Service Bulletin

Starair Aircraft Co., Ltd.

Document No.: 2024-SA60L-32-01

Subjct	Replacement of nose wheel support shaft
Category	Important
Applicability	This bulletin (English version) applies to the Aurora SA60L light sport aircraft listed in Attached Table 1.
Finish Time	Aircraft listed in Attached Table 1 shall complete the replacement of the nose wheel support shaft by April 30, 2025.
Reason	<p>The nose wheel assembly comprises the following components: nose wheel support axle, front landing wheel articulated fork, aluminum axle bushing, adjustment shim, bearings, wheel hub, and fastening nuts. Under normal operating conditions, the nose wheel support axle is designed to withstand ground ultimate loads, which has been rigorously validated through testing. However, improper installation procedures or exposure to hard landing scenarios may subject the axle to stresses exceeding its design limits, potentially resulting in structural failure.</p> <p>To enhance operational safety, our company has implemented structural reinforcement measures to the nose wheel support axle (Part Number: 304020001025). All applicable aircraft within the specified service scope are required to rep

Cutaway view of the front wheel

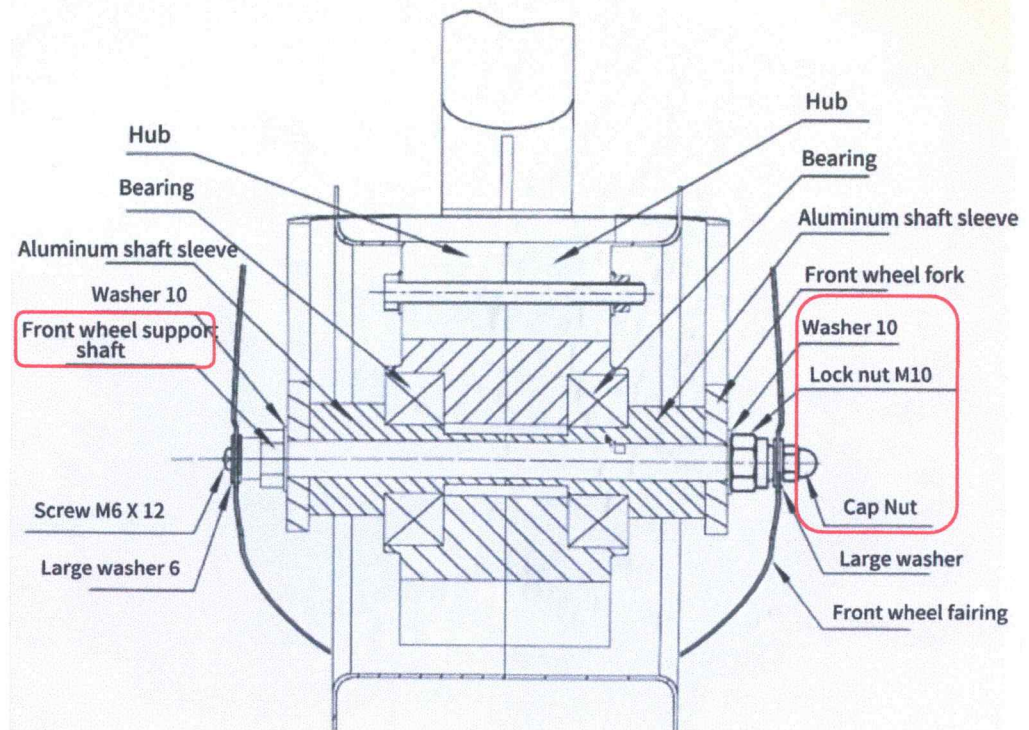
5. Upgraded Axle Installation Procedure: replace components as indicated in the enclosed diagram. Install the front wheel support axle from left to right as shown. Apply LOCTITE 243 to the M10 threaded area and torque the lock nut to 24 N • m.

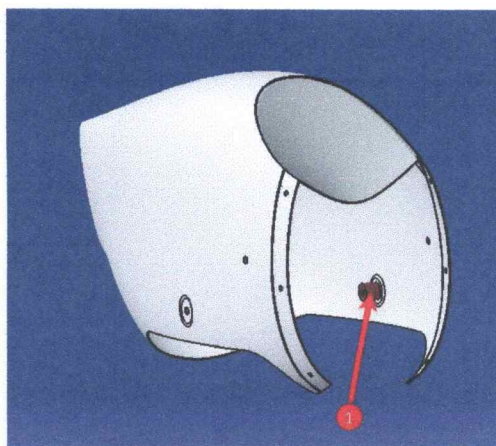
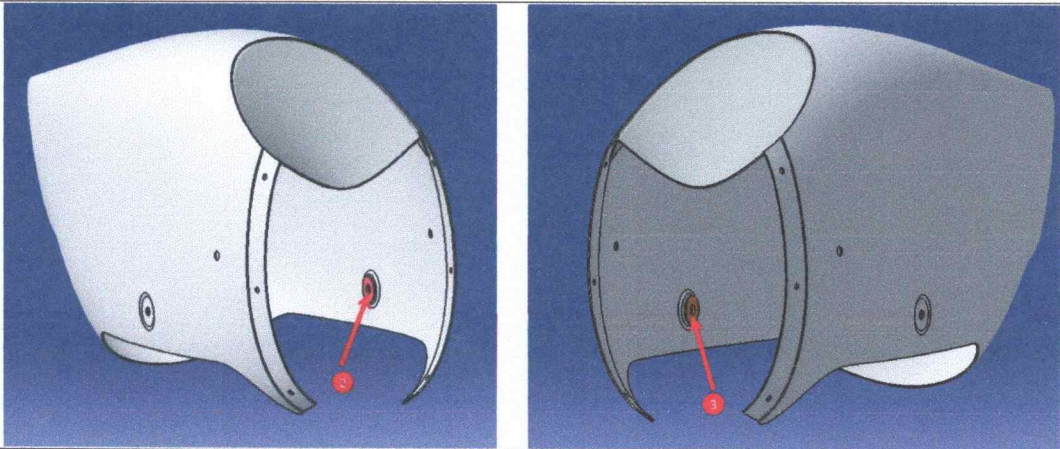
7. Modification of the front wheel fairing (Part Number: 334020000100): As shown in the figure below, remove Part No. 1, and bond an M8 GB/T96.1 washer with structural adhesive at the locations of mounting holes No. 2 and 3 on both sides.
